**BIDDING AND CONTRACT DOCUMENTS FOR
CABARRUS COUNTY, NORTH CAROLINA
CONSTRUCTION AND DEMOLITION DEBRIS LANDFILL
PHASE 1L EXPANSION PROJECT**

CDM PROJECT NO. 1278-77070

ADDENDUM NO. 2

Date Issued: October 13, 2010

Sheet No. C-4

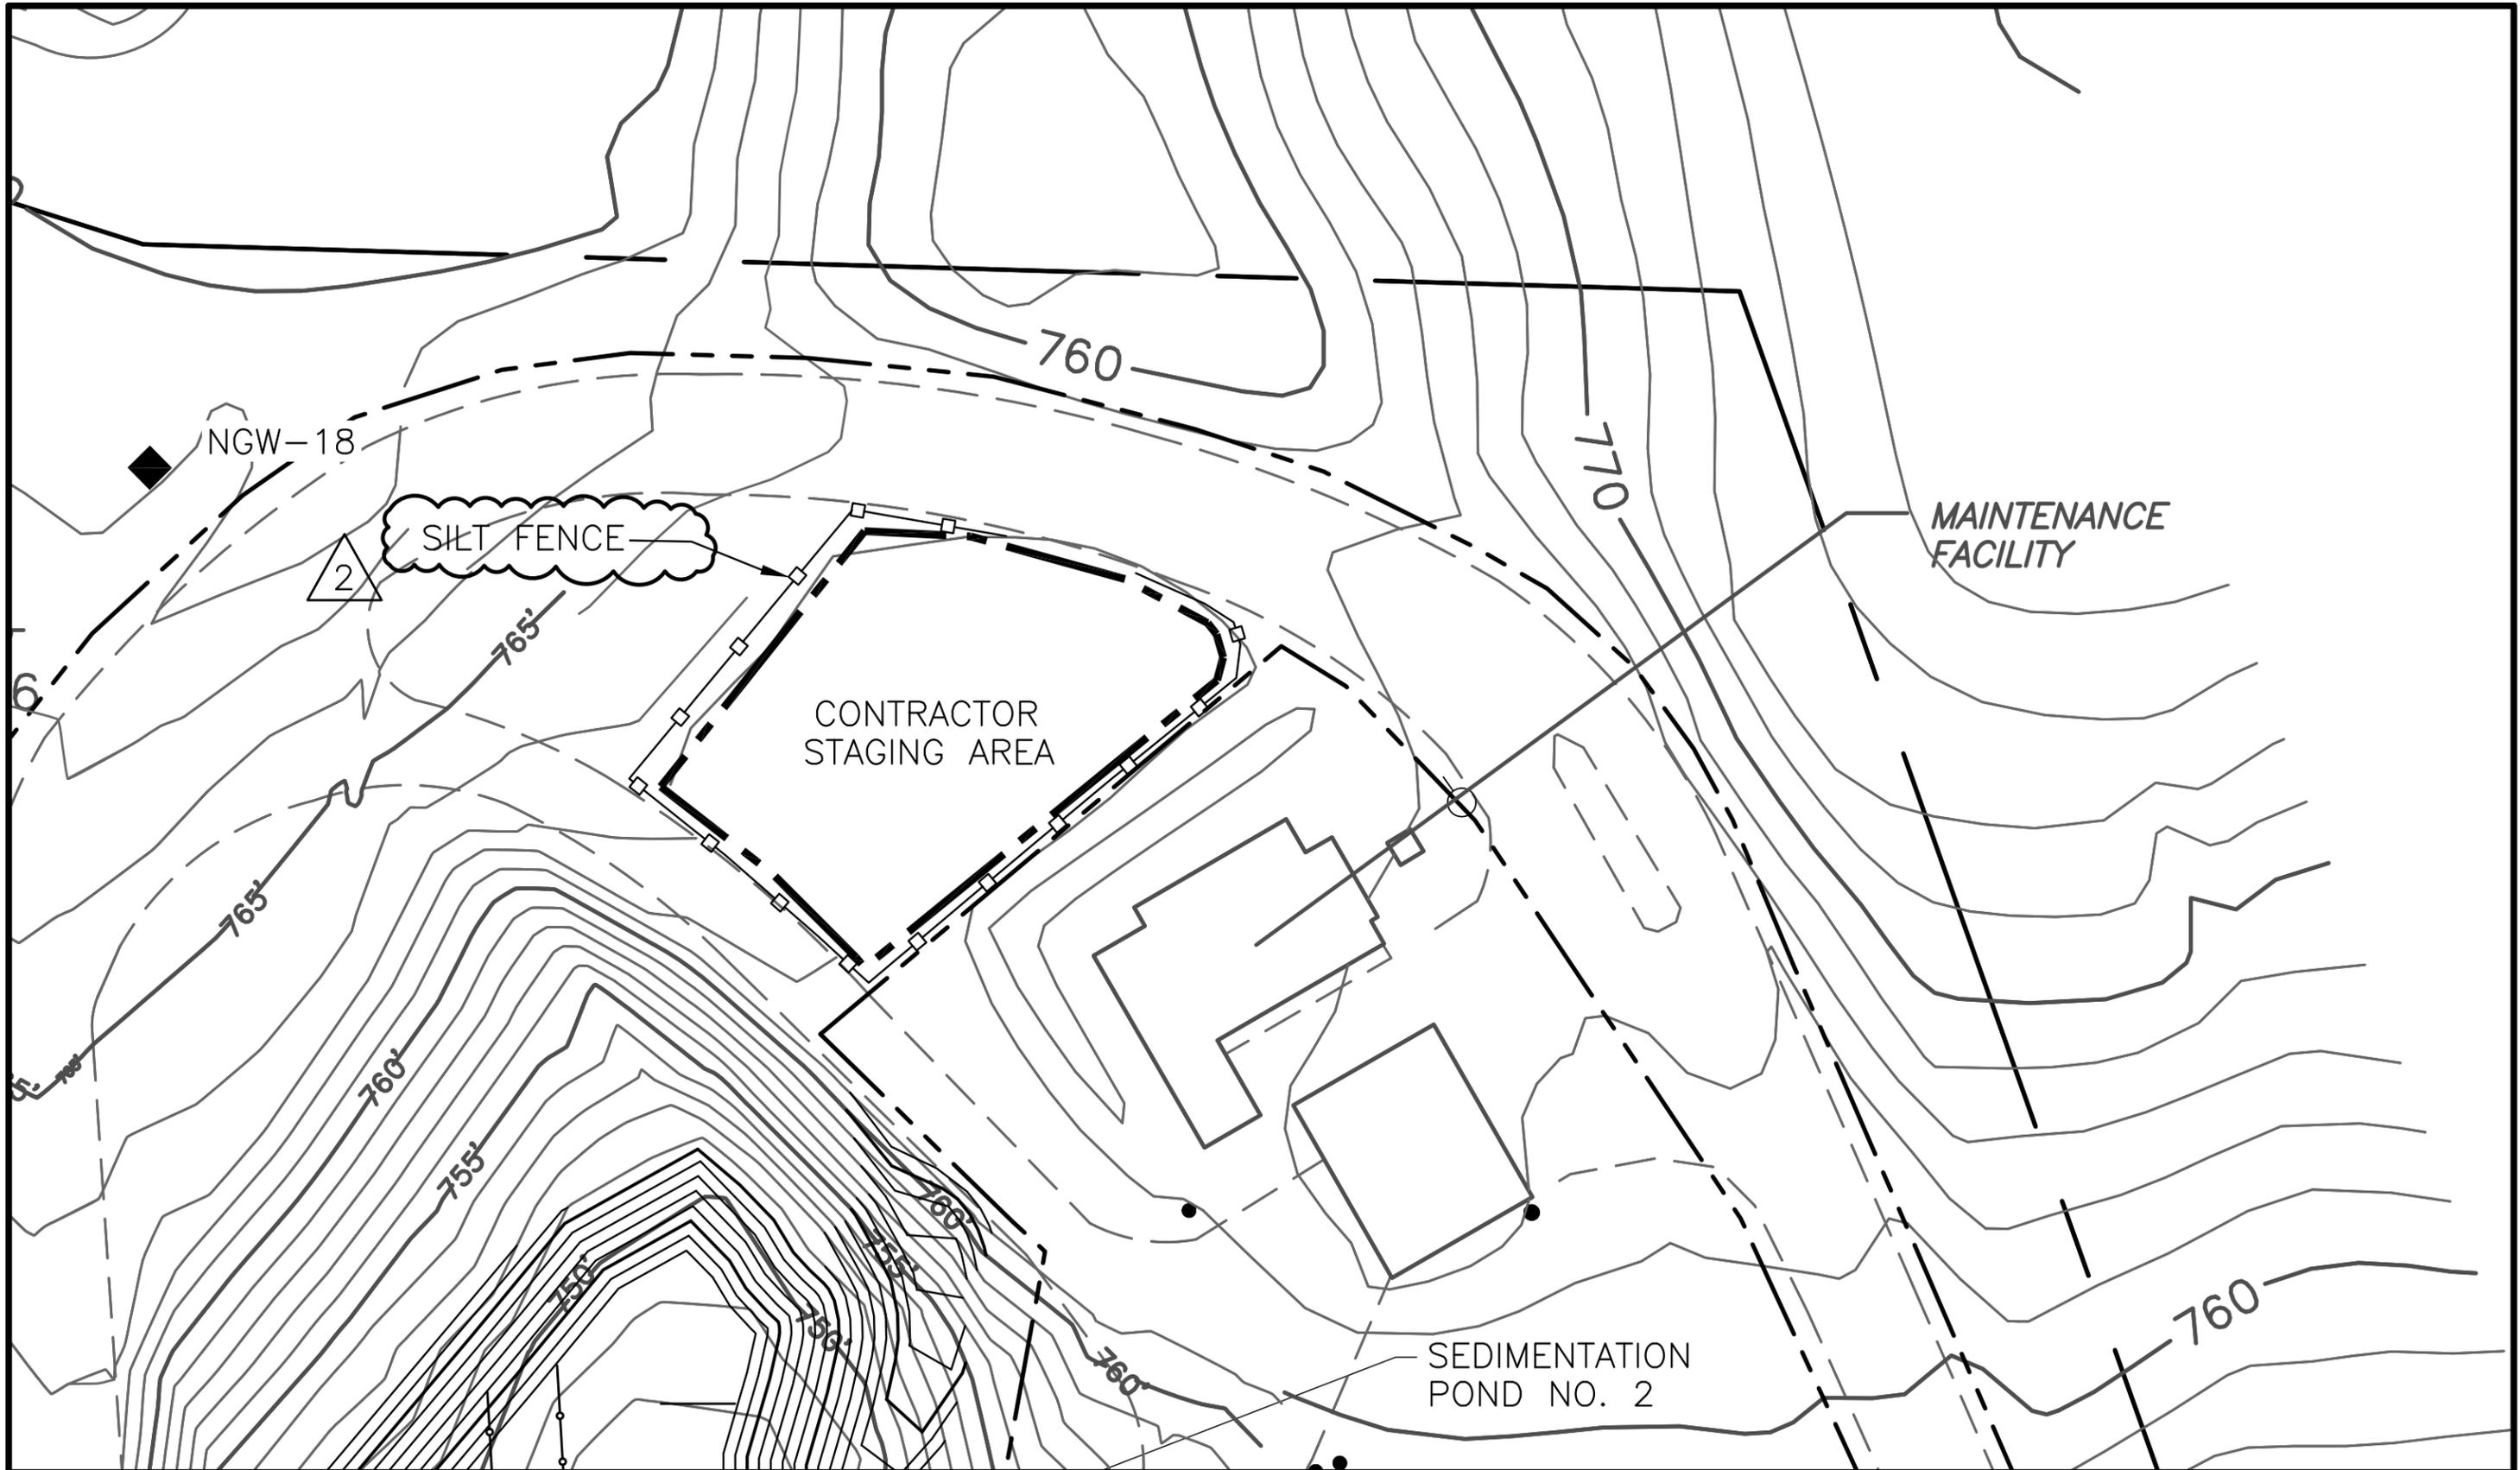
1. Added silt fence around the Contractor staging area as shown on Figure No. 1.

SHEET NO.	LOCATION	ADDENDUM NO.	FIGURE NO.
D-2		2	2

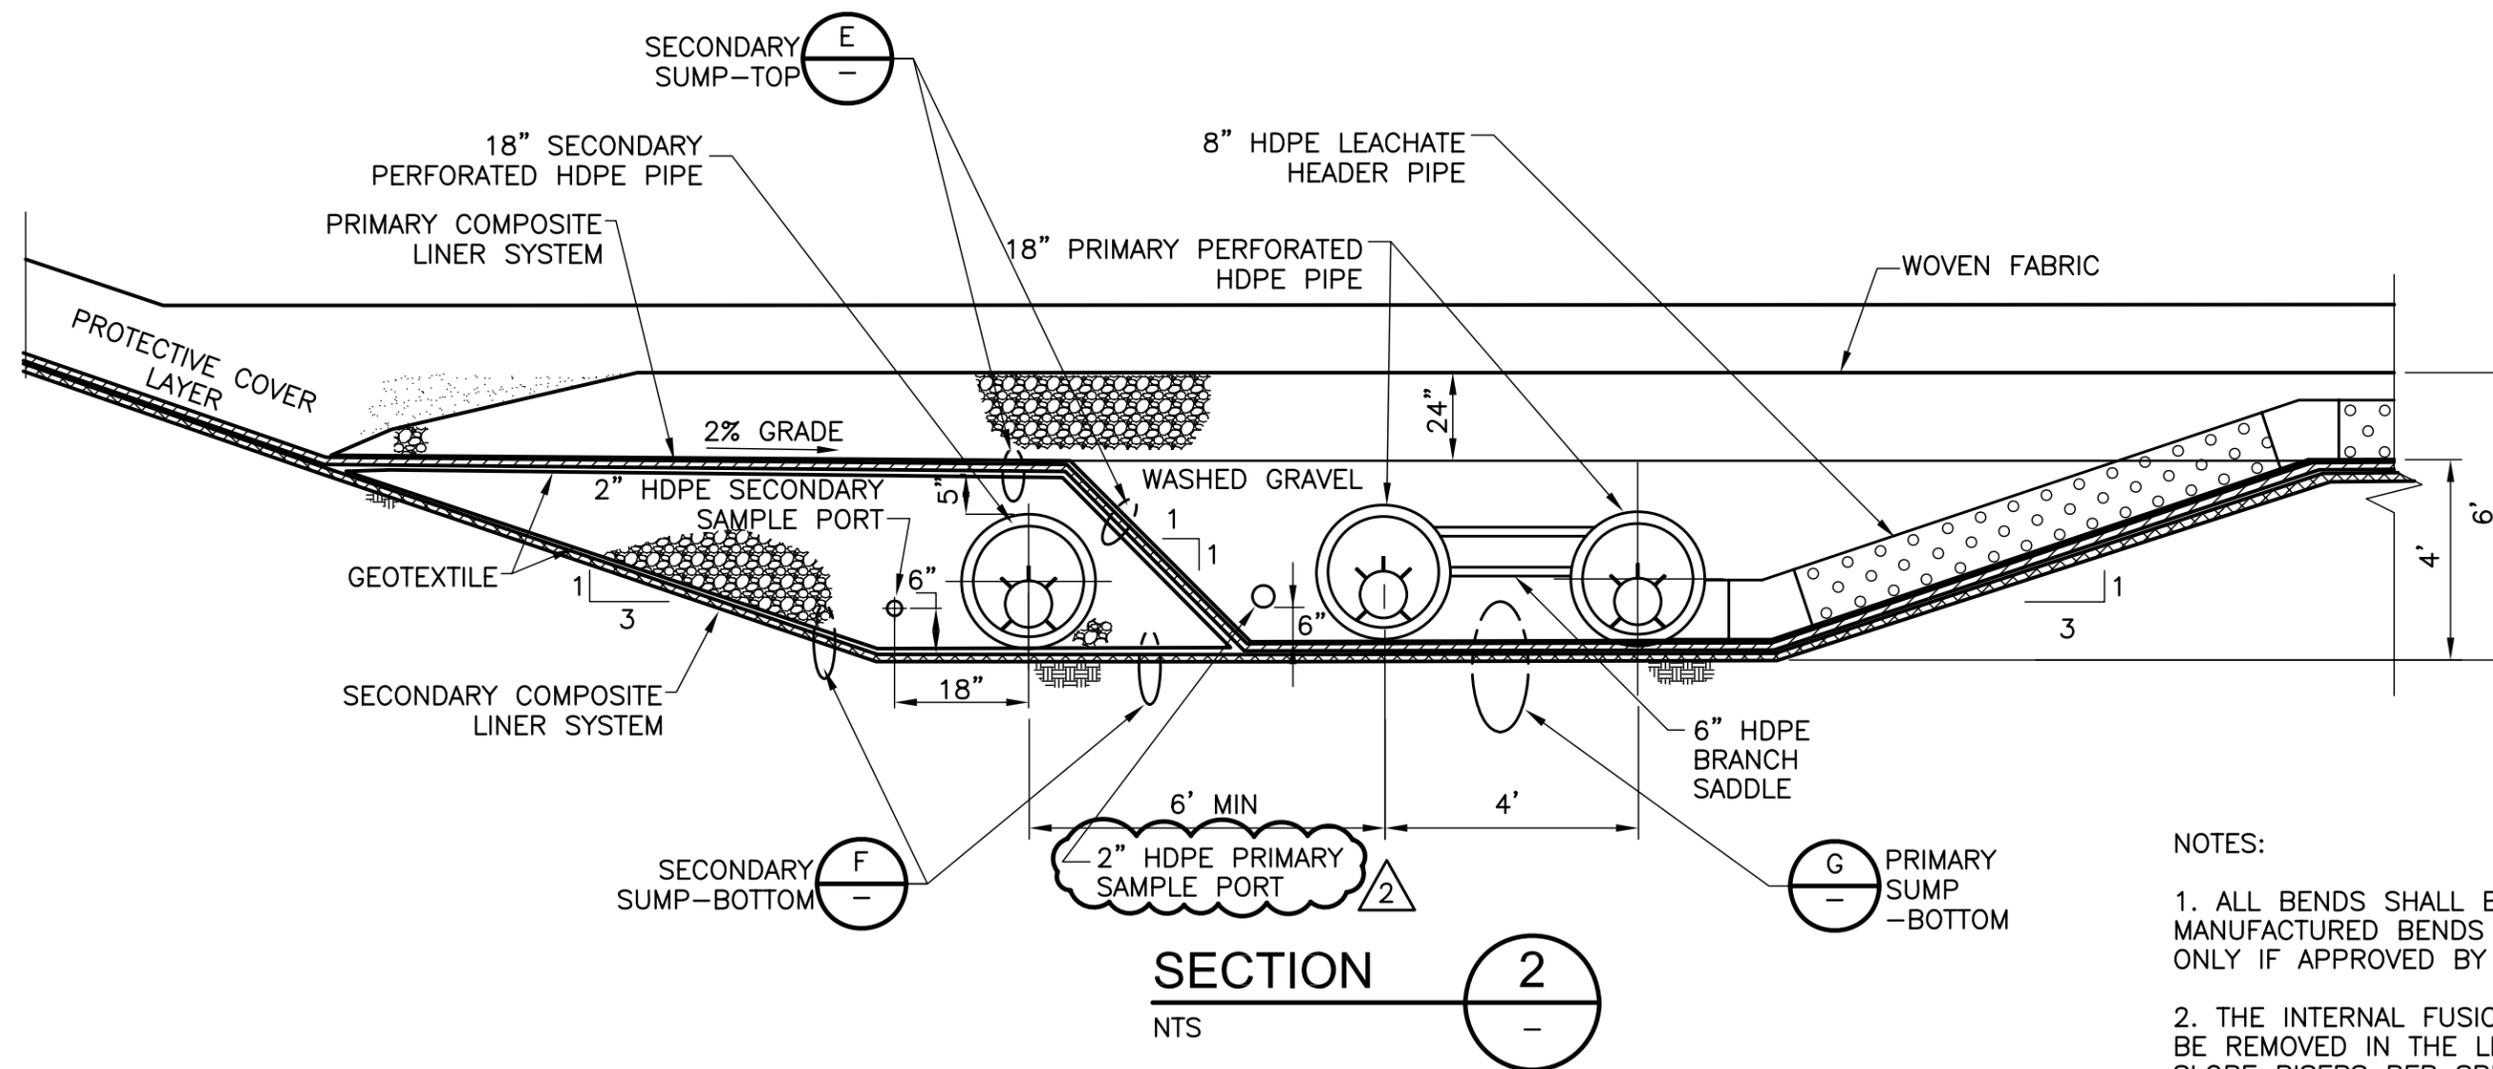
1. Detail D - Section 2 – Added 2-inch HDPE primary sample port as shown on Figure No. 2.

DATE 10/10	SHEET NO.	LOCATION	ADDENDUM NO. 2	FIGURE NO. 3
	D-2

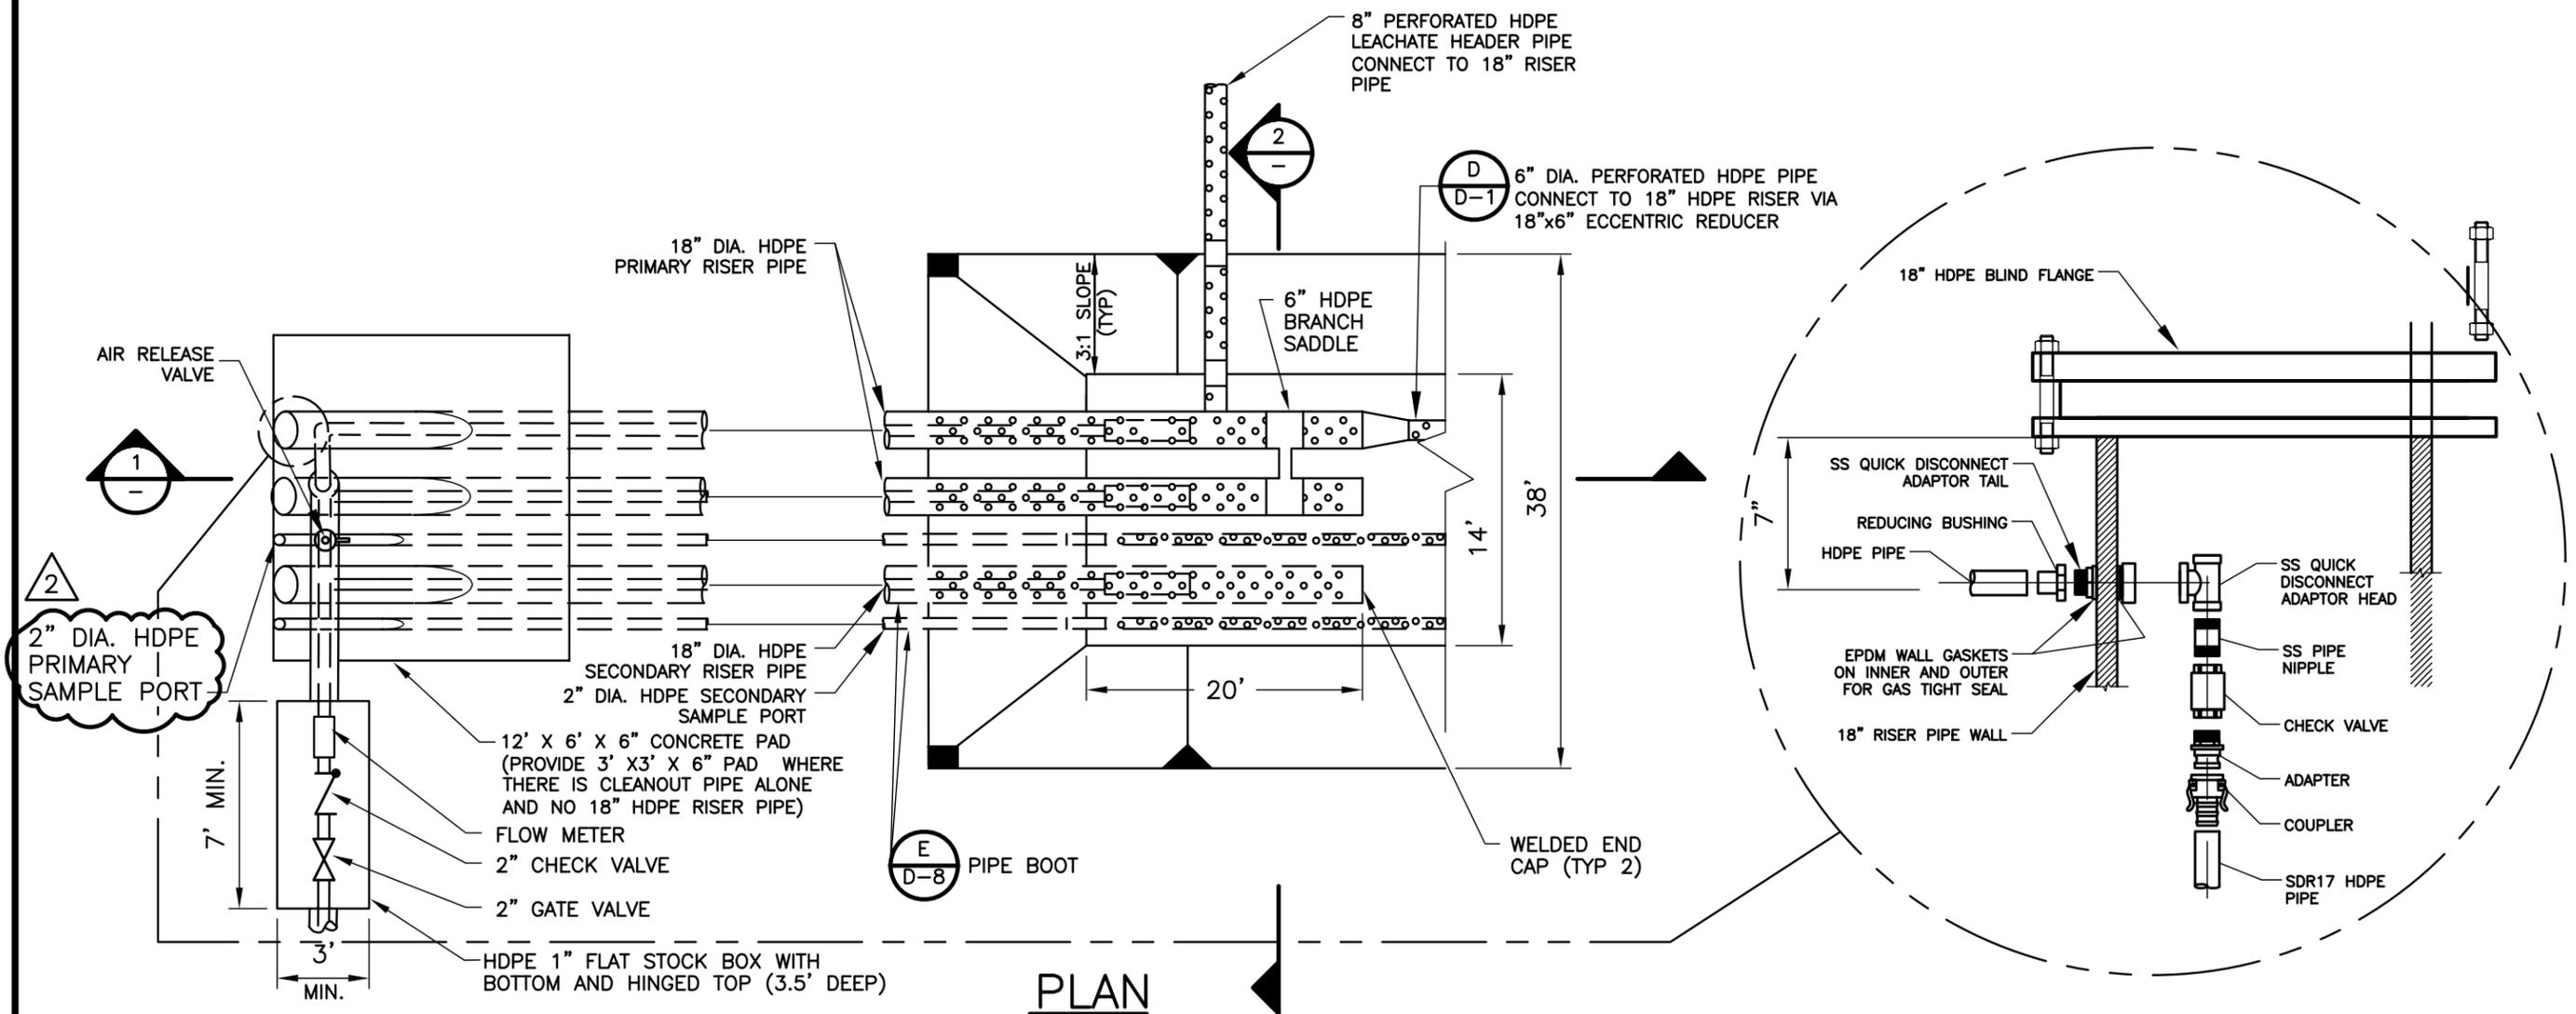
2. Detail D - Plan view – Added 2-inch HDPE primary sample port as shown on Figure No. 3.
